Technical Evaluation Report

For the Revised Performance Assessment
for the Saltstone Disposal Facility at the
Savannah River Site, South Carolina

Final Report

U.S. Nuclear Regulatory Commission
Office Of Federal And State Materials
And Environmental Management Programs
Washington, DC 20555-0001

Figure 2.5-2: DOE Case A modeled Hydraulic Conductivity and Diffusion Coefficient for HDPE Lining of FDCs After Closure (2009 PA, Figure 4.2-42)

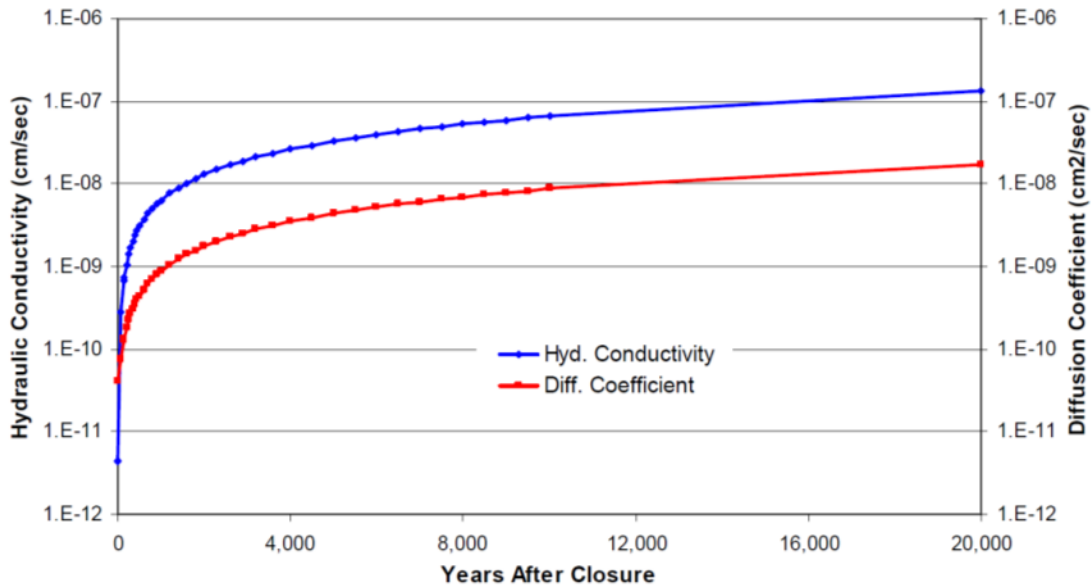
⁹ The reported initial hydraulic conductivity of HDPE is significantly different from the value of 5.9×10^{-10} cm/s used in the first modeling times step, as presented in SRNL-STI-2009-00115, Appendix E (unnumbered table on page 234). These values differ by more than the expected difference between the initial values and the average values for the first time step. Both of these values differ from the initial value depicted in Figure 2.5-2.

Figure 2.7-1: Vertical Darcy velocity through saltstone in Vault 4 predicted with the DOE PORFLOW™ model. Data for the Synergistic Case excludes fractures (other cases do not represent fractures explicitly). Data taken from DOE's STAT.out files (NRC, 2010g).

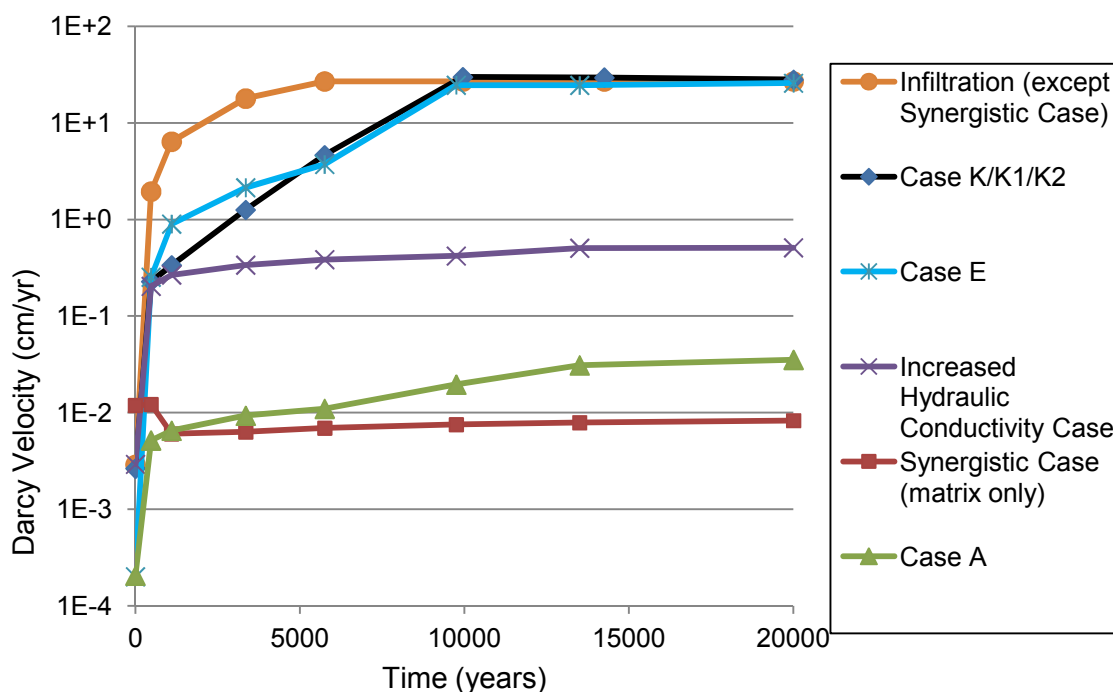
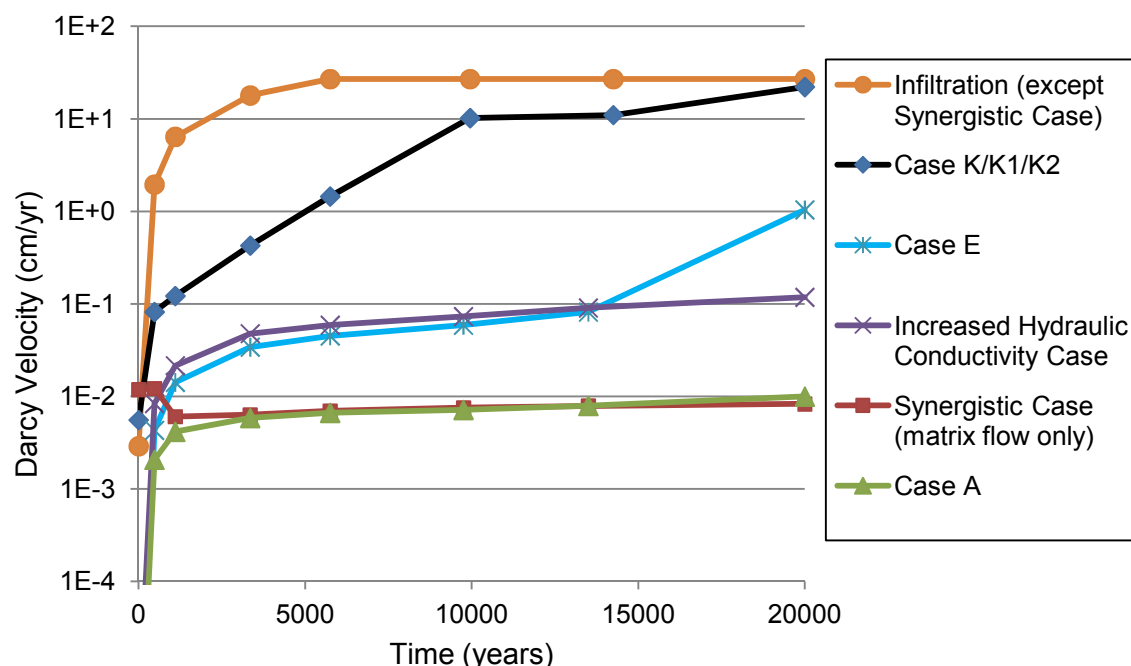
As discussed in more detail in Sections 2.5 and 2.6, the NRC staff found that the assumed low hydraulic conductivities of saltstone and the disposal unit concrete used in Case A and many of the deterministic sensitivity cases were overly optimistic. Similarly, assumptions regarding the performance of the lateral drainage layer, the disposal unit roofs, and the HDPE/GCL layer (for the FDCs) resulted in a significant amount (i.e., greater than 99% of the infiltrating water being shed around the disposal units even 10,000 years after site closure in Case A and several of the deterministic sensitivity analyses (Section 2.5) (SRR-CWDA-2011-00044; IEC-8). As discussed in Sections 2.5 and 2.6, the NRC staff finds that Cases K, K1, and K2 more realistically represent the current and expected future hydraulic and physical properties of the saltstone and disposal units. In these cases, the modeled flow through the saltstone and disposal units does not appear to be inappropriately constrained (Figures 2.7-1, 2.7-2, and 2.13-1).

With respect to flow modeling, the NRC's analysis of DOE's near-field model indicates that Case A appears to severely constrain flow through saltstone (Figures 2.7-1 and 2.7-2). As discussed in detail in Section 2.6, the saltstone hydraulic conductivity that contributes to this low flow value is inconsistent with recent measurements and does not reflect any degradation of the hydraulic conductivity as the saltstone ages. Flow through the saltstone and disposal unit concrete in the PA Cases (i.e., cases other than Cases K, K1, and K2) were further limited by moisture characteristic curves that are inconsistent with curves found in the literature for similar materials. DOE demonstrated that the effect of the suspect moisture characteristic curves is limited to a factor of 2 in Case A (Section 2.7.3), however, the effect may be greater if other engineered barriers do not perform as modeled. Because of the large uncertainty in the potential degradation of saltstone, disposal unit concrete, and the HDPE/GCL layers on the FDCs, and because of the importance of these barriers to system performance (Section 2.13), the NRC staff will monitor the development of model support for the long-term performance of these materials.

Figure 2.7-3: Moisture Characteristic Curves Adapted from the PA and WSRC-STI-2006-00198 (SRR-CWDA-2010-00033; Figure 1)

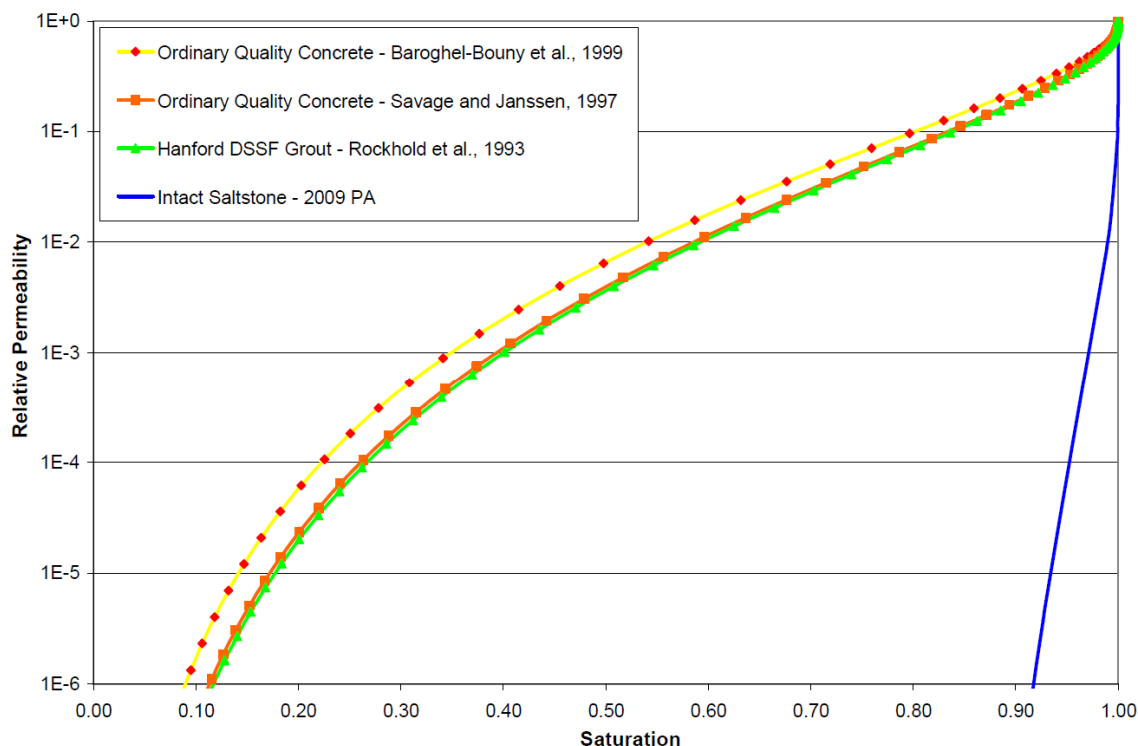
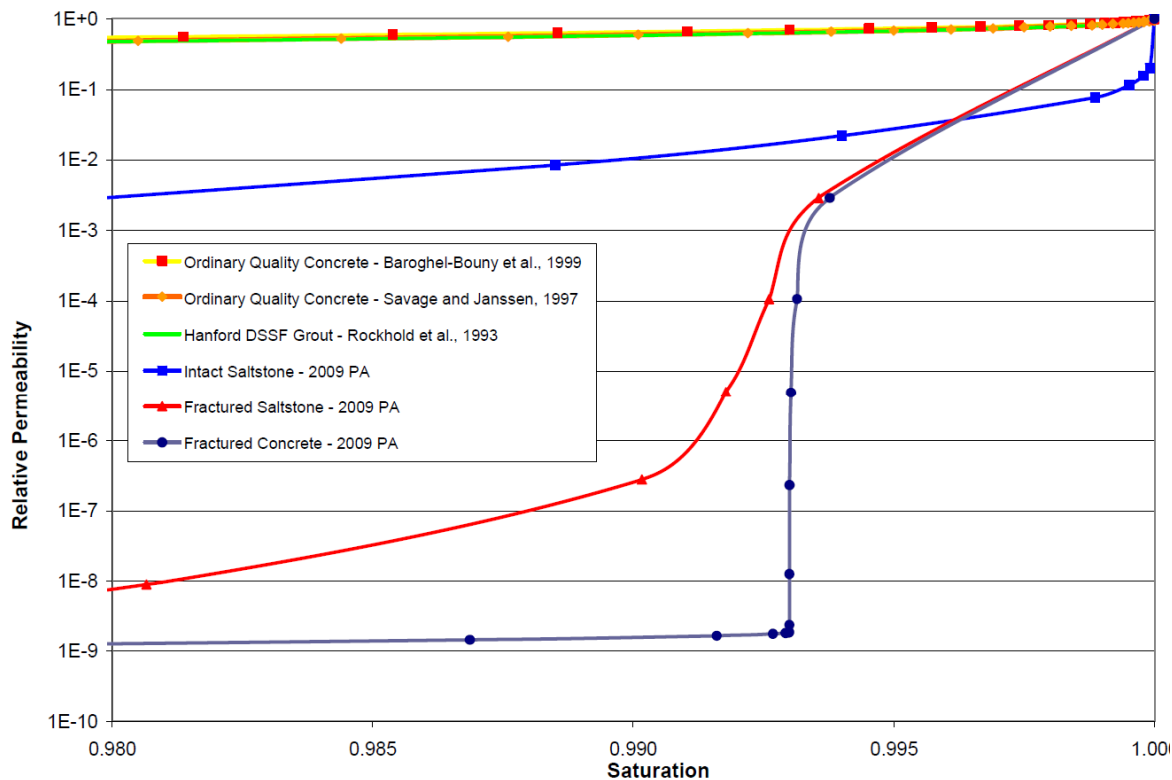
In response to NRC's concern about the moisture characteristic curves in intact saltstone, DOE agreed that the moisture characteristic curve utilized in the PA for intact saltstone is inconsistent with the literature (SRR-CWDA-2010-00033; SP-3). To evaluate the impact of moisture characteristic curves, DOE performed a sensitivity case based on Case A with the relative permeability for intact saltstone fixed at 1.0 (i.e., the hydraulic conductivity was not reduced based on moisture characteristic curves) for the most risk significant radionuclides. The resulting contaminant release rate was approximately twice that of the original Case A result for an FDC within 10,000 years after site closure. For Vault 4, with the relative permeability equal to 1.0, the release rate of Tc-99 was almost doubled, while the I-129 and Ra-226 rates increased by less than 30% as compared to the original Case A values. DOE stated that these increases in release rates would not significantly impact the resulting dose to the member of the public. In addition, DOE performed a sensitivity case based on the Synergistic Case with a revised saltstone relative permeability of 1.0 and concluded that the sensitivity case showed no significant impact on the resulting dose (SRR-CWDA-2010-00033, VP-2). Based on these analyses, DOE concluded that the moisture characteristic curve used in the PA for intact saltstone does not appreciably impact the estimated dose to the member of the public.

However, as NRC indicated in response to these DOE analyses (NRC, 2010i; SP-3), one-off sensitivity analyses may result in insignificant increases in the dose on an absolute basis; however, the effect on dose results may be significant when there are many outstanding uncertainties that are evaluated on a cumulative basis. In response to the second RAI (SRR-CWDA-2011-00044), the DOE provided a more comprehensive analysis, Case K, to address the NRC staff's concern with DOE's moisture characteristic curve for intact saltstone as well as other concerns. In this analysis, DOE fixed the relative permeability to one for the cementitious materials (i.e., moisture characteristic curves were not used). NRC staff finds that this approach is reasonable due to the (i) uncertainty in unsaturated flow through cementitious materials over long periods of time and (ii) limited amount of reduction in flow that would be expected for cementitious materials that are predicted by DOE to be near saturation. Case K also addressed NRC staff's concern with the moisture characteristic curves that were used to represent unsaturated flow through fractured saltstone and concrete.

DOE used an analytical approach to develop curves for fractured cementitious materials in the PA based on the moisture characteristic curves that were to represent intact saltstone. Figure 2 of the first RAI response (SRR-CWDA-2010-00033) shows the curves for fractured saltstone (used to represent the saltstone grout in Case E) and fracture concrete (used to represent the walls of Vaults 1 and 4 in all of the cases in the PA except the Synergistic Case) (Appendix E of SRNL-STI-2009-00115; SRR-CWDA-2010-00033). The figure illustrates that a decrease in the saturation of the walls of Vaults 1 and 4 from 100% to 99% results in an unrealistic decrease of nine orders of magnitude in relative permeability. The NRC staff's concern, as discussed in the

Figure 2.13-4: Water shedding around Vault 4 in DOE Case A at 0 and 8,000 years after site closure (left top and bottom) as compared to an NRC interpretation of known conditions (top right) or potential future conditions considering uncertainty (bottom right)

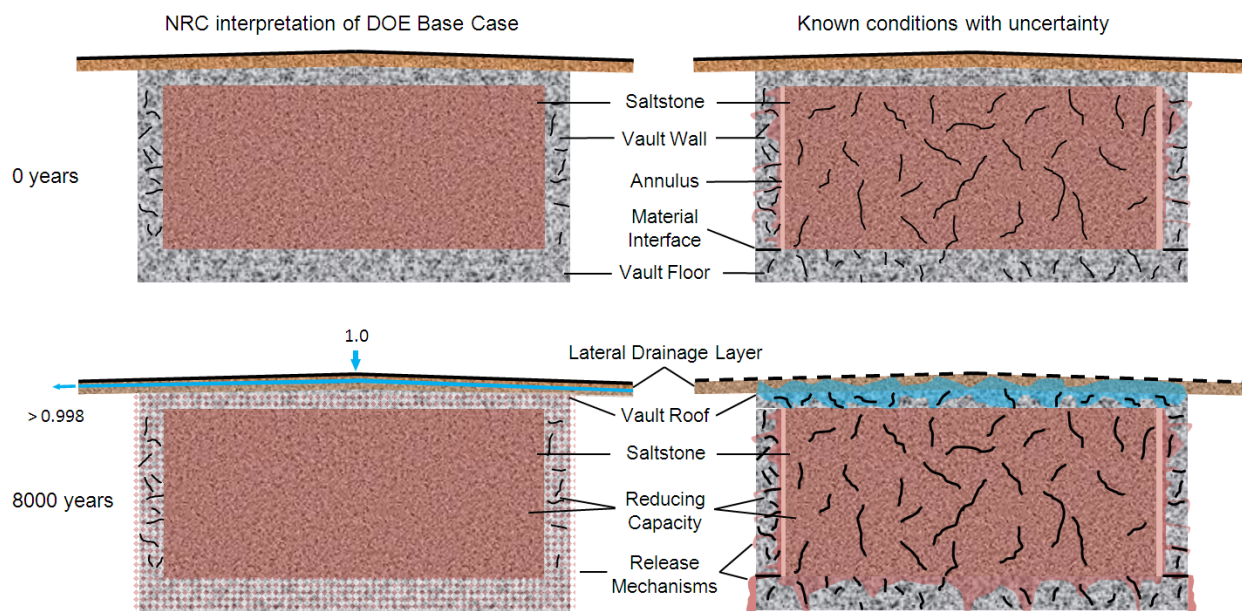
drainage layer, demonstrates the importance of the large contrast between the modeled hydraulic conductivity of the lower lateral drainage layer and the layers it overlies above each disposal unit (i.e., the roof for Vault 1 and 4, the HDPE, geosynthetic clay liner, and roof for the FDCs).

Figure 2.13-8 Comparison of annual fractional release from saltstone predicted by NRC's simple analytical average- K_d and dual- K_d models, using DOE Case K1 fracturing, near-field flow, and K_d values. Both models simulate the same cumulative release.

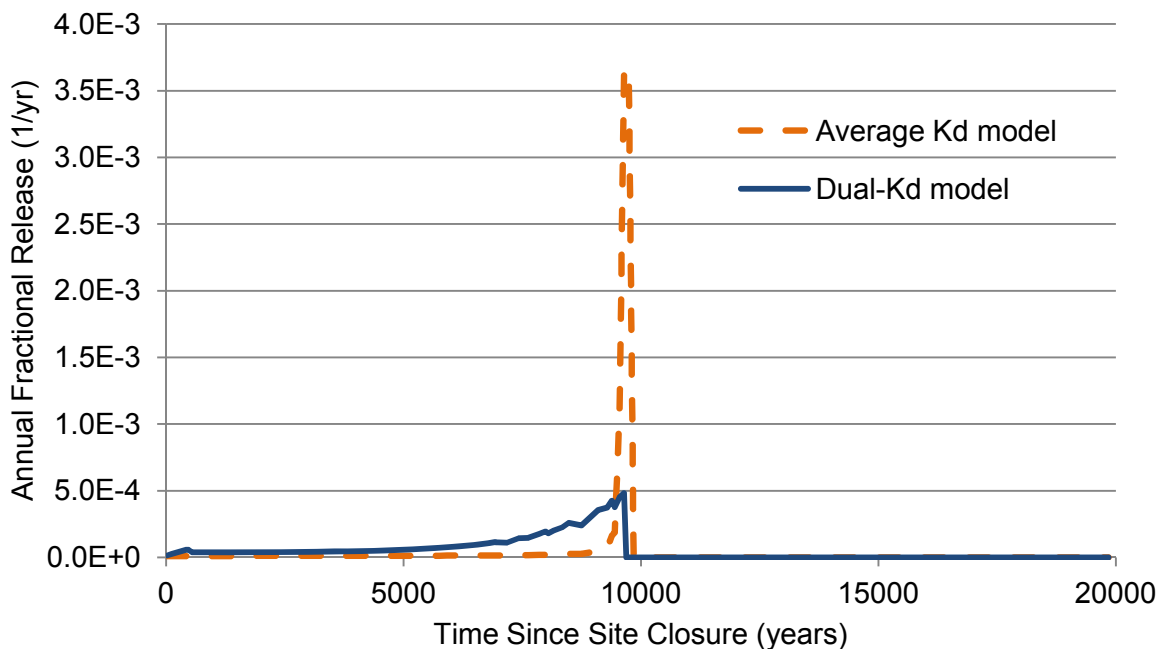
Comparison of the simple average- K_d and dual- K_d models indicates that the average- K_d model can under-predict releases in the short-term and significantly over-predict peak release rates in some cases (Figure 2.13-5). The NRC staff calculations indicate the average- K_d model over-predicts release rates most significantly in cases in which most of the release comes from the oxidized, rather than the reduced, fraction of saltstone. Thus the effect is most pronounced when there is relatively low water flow through saltstone to release Tc from the reduced region before significant oxidation occurs. Comparison of model results indicates that the dual- K_d model allows a more gradual release of radionuclides, resulting in a smaller available inventory at times when the average- K_d model would predict nearly the entire initial inventory is released with a relatively low average sorption coefficient. This result is similar to the result of DOE's comparison of an average- K_d model and a dual- K_d model (which DOE refers to as single- and dual-porosity models) (SRR-CWDA-2011-00114), although the NRC staff's simplified models predicted a more substantial difference between the two approaches than predicted by DOE. The magnitude of the overprediction of peak dose that both NRC and DOE expect the average- K_d model to cause is unclear. DOE's conclusion that the average- K_d model provides a good representation of Tc release is based on a comparison of two GoldSim® models rather than a comparison involving the actual PORFLOW™ model DOE used to model Tc release. NRC staff concluded DOE's GoldSim® comparison was likely to underestimate the difference between the models, as compared to a similar comparison performed in PORFLOW, because of certain implementation details in DOE's GoldSim® models (Section 2.7). However, the DOE models include diffusion between the oxidized and reduced regions, which is an important process not included in the simplified NRC staff models. In DOE's Case K, K1, and K2 analyses, the expected over-prediction of peak dose attributable to the average- K_d model is further obscured by the re-concentration and gradual re-release of Tc from the disposal unit floor and walls (Figure 2.13-7).
